Structural Assessment
Garberville Veterans Building
Garberville, CA

KPFF Consulting Engineers
San Francisco, CA
February 26, 2021

STRUCTURAL ASSESSMENT

**CONCEPTUAL SKETCHES:
WALL ELEVATIONS
KPF**

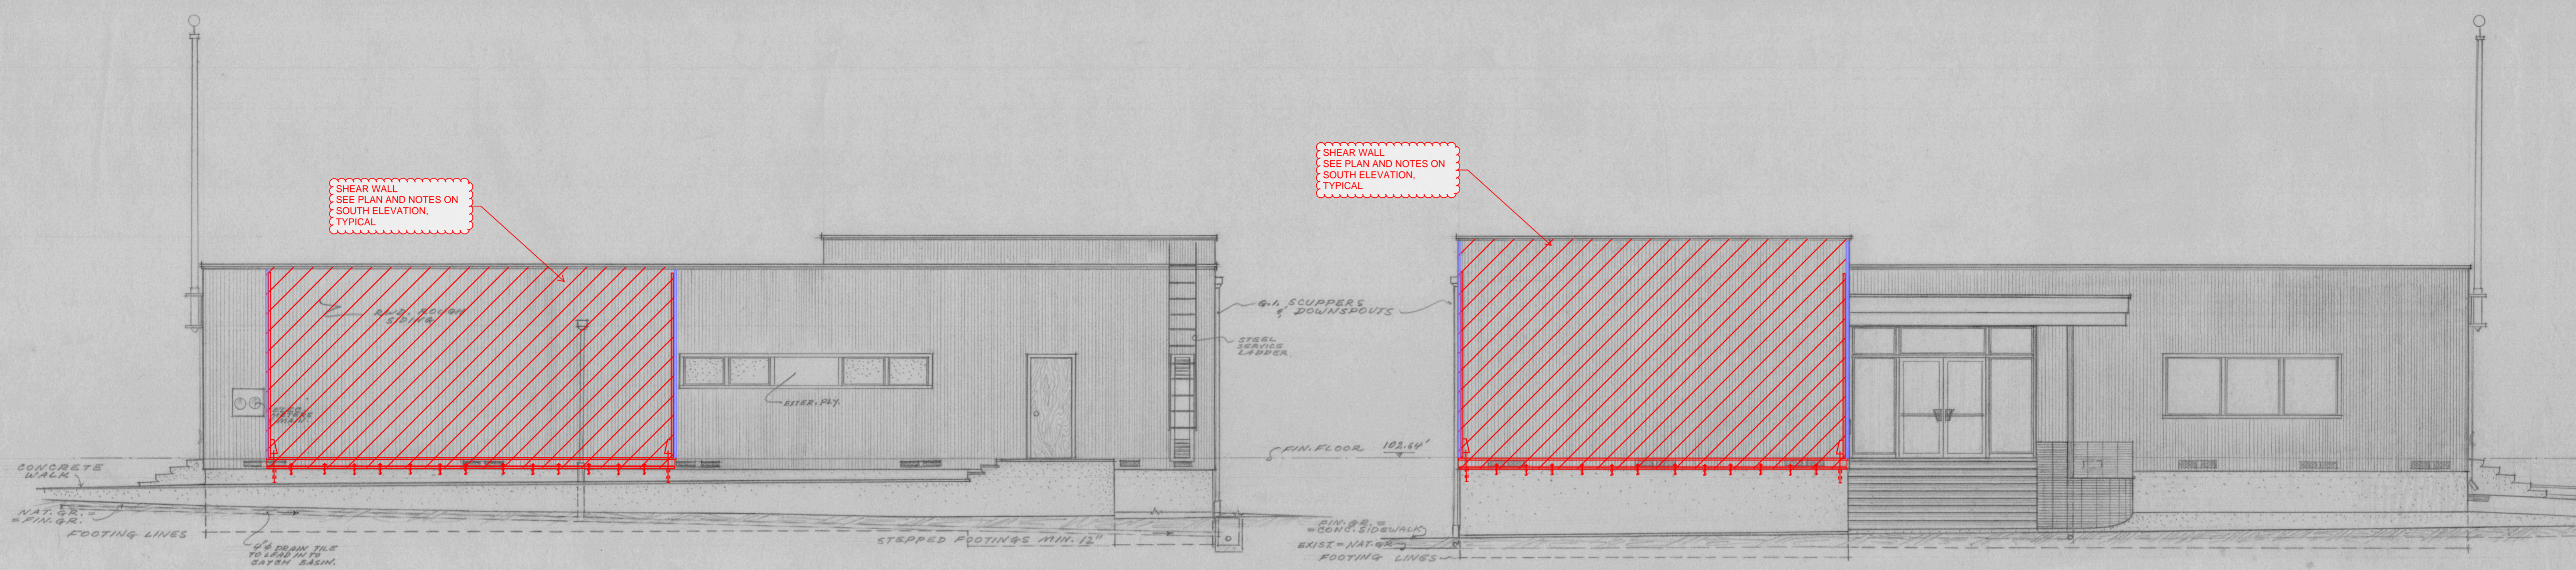
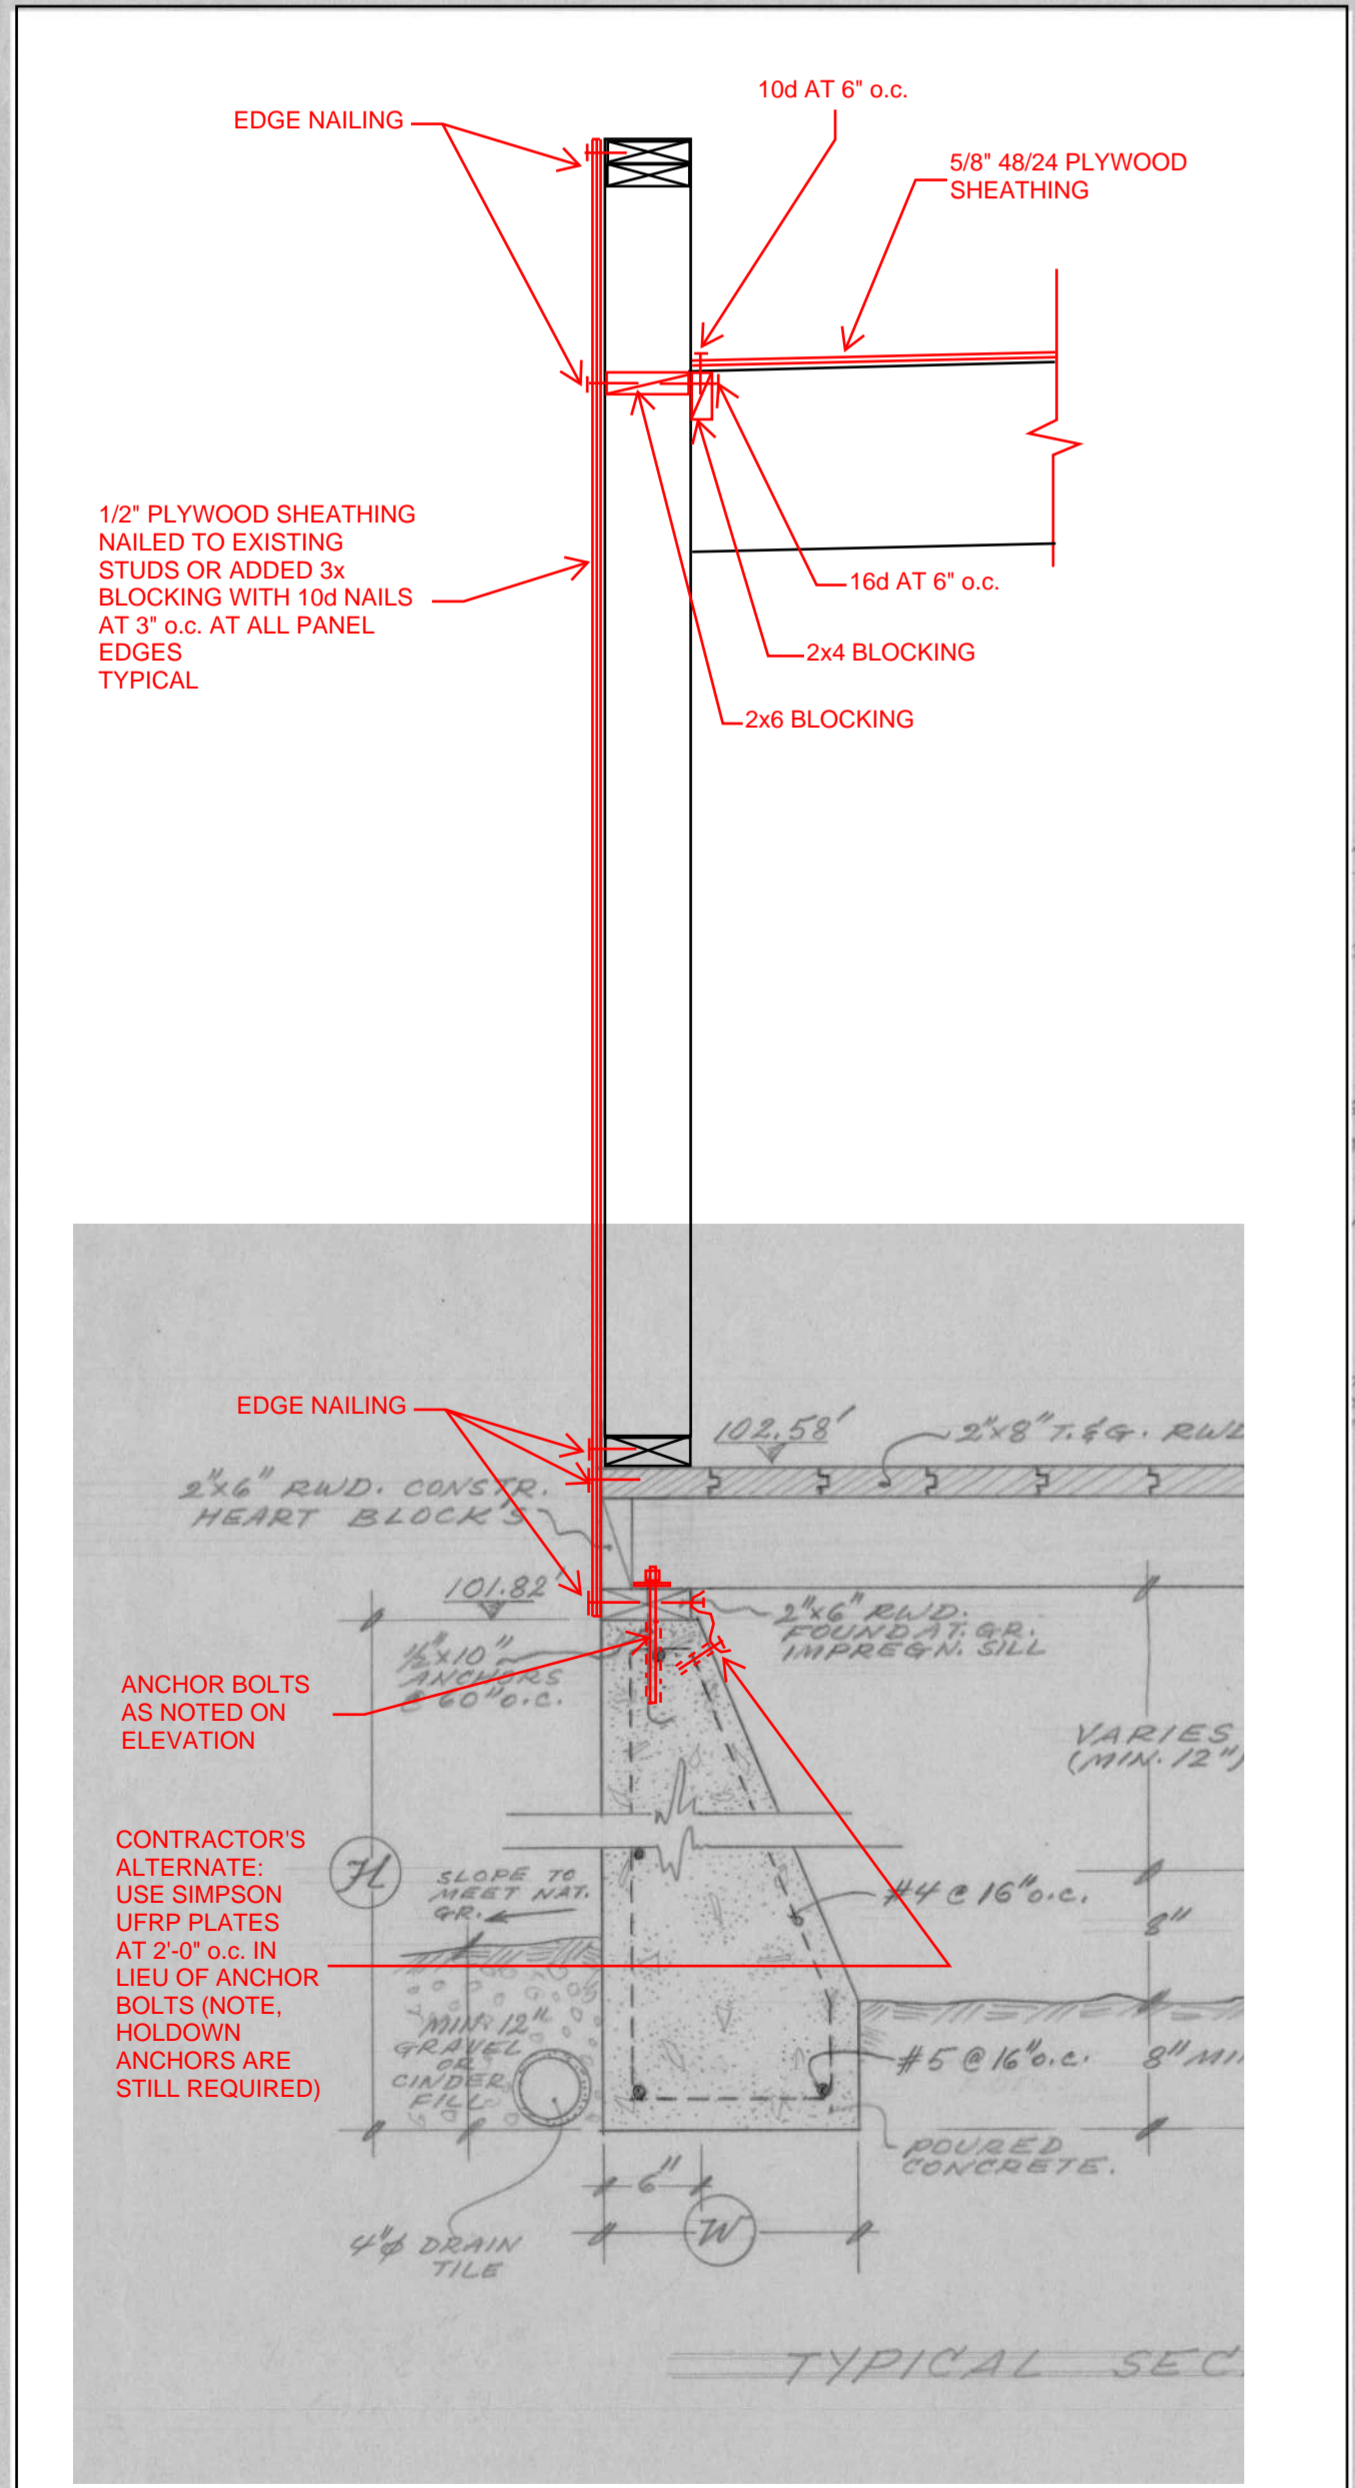
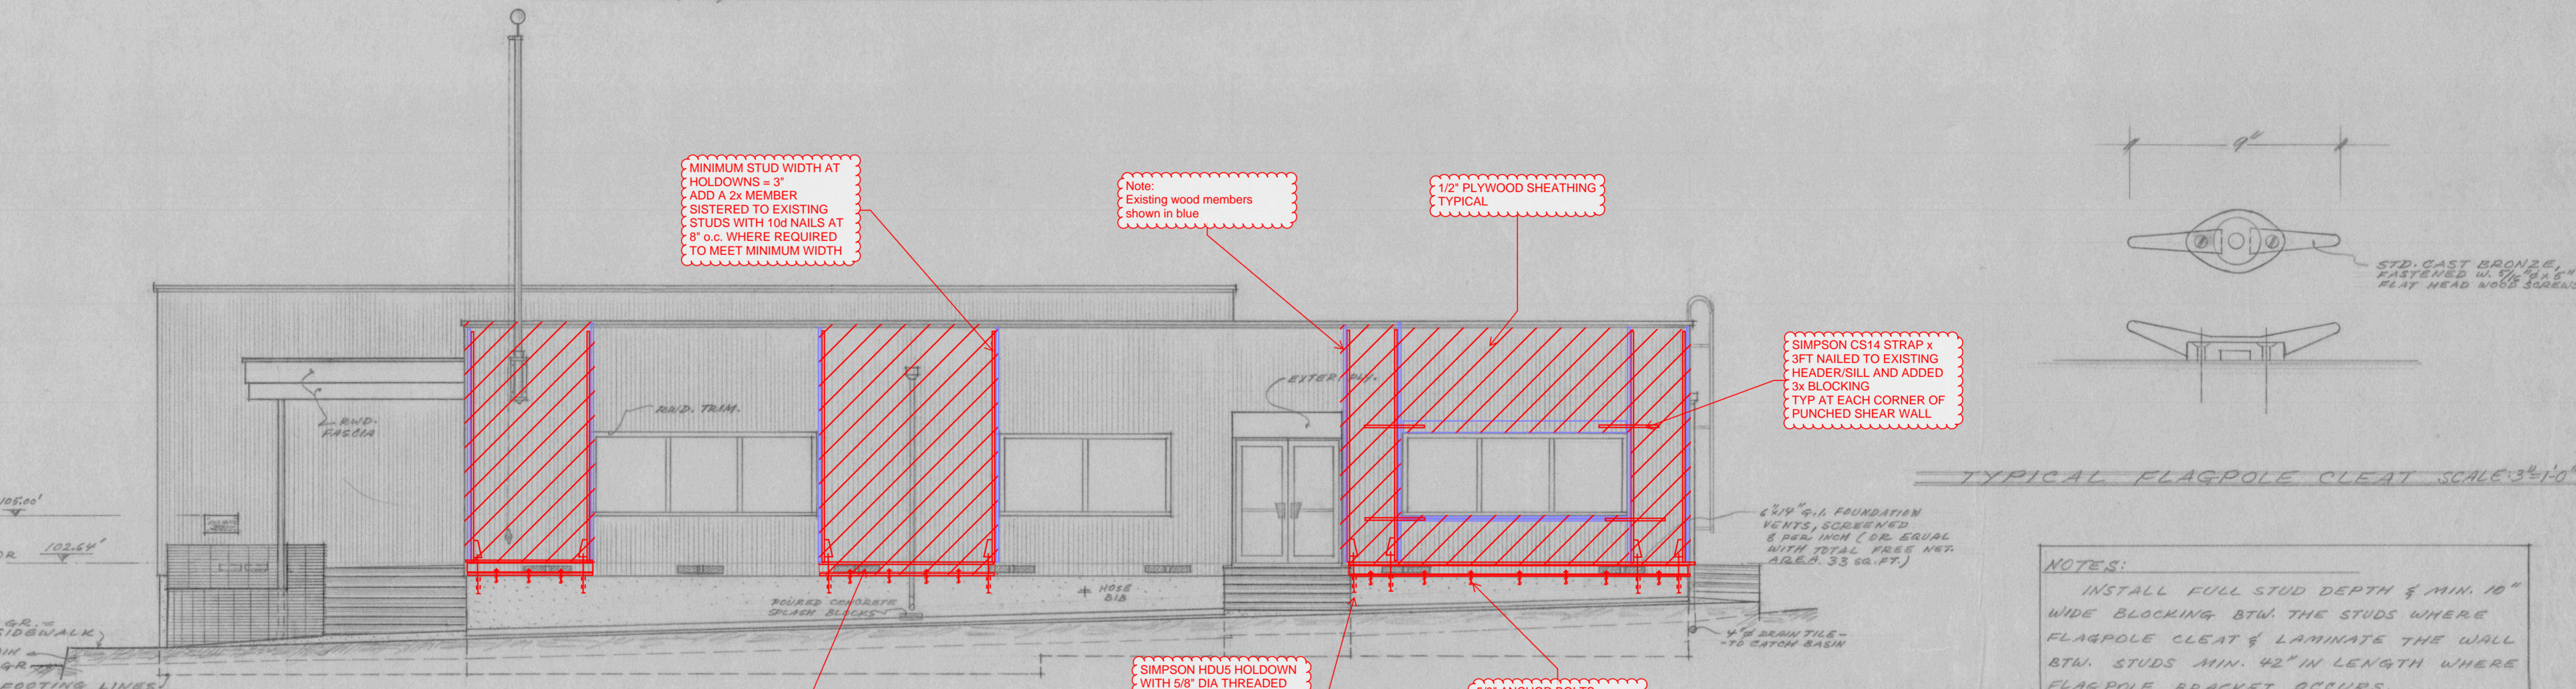
- 7.5 Sheath exterior walls with 1/2" CDX plywood. At least 20 feet of sheathed wall is required on 4 sides of the building. The sheathing may be installed on the inside surface of the walls. Add post-installed anchors at approximately 18" o.c. to connect the new shear walls to the foundation. At the end of each wall, add 4x6 or double 2x6 posts connected to post-installed hold-down anchors.
